SIB 65 15 13

Recall Campaign 13V-172: Passenger Front Air Bag Module

This Service Information bulletin (Revision 5) supersedes SI B65 15 13 **dated** December 2018.

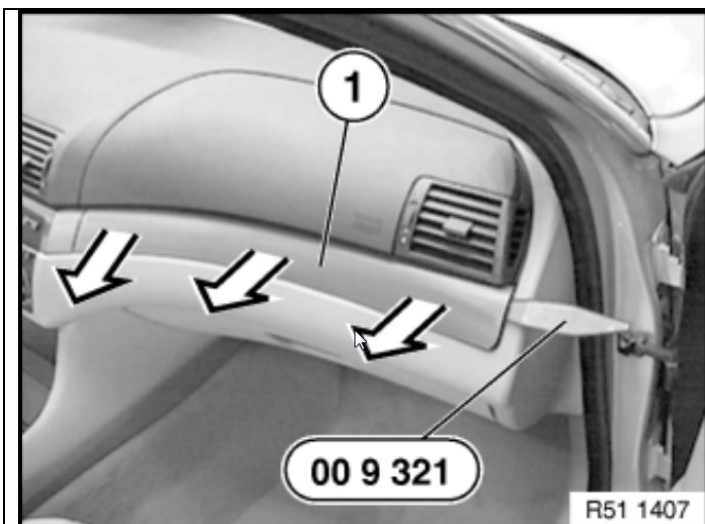
- The only parts allowed to be installed in this repair are the part numbers supplied in the PARTS INFORMATION section. Warranty will not pay for any other part numbers used.
- **The replacement air bag module's serial number (circled below) must be documented on the repair order so it can also be entered into the claim's comment section.**

Make a note of the new airbag module serial number prior to installation. The serial number for the new airbag module must be entered in the comment box in the warranty application. Ensure that you enter the serial number without any blank spaces. Otherwise, it is not possible to uniquely assign the number.
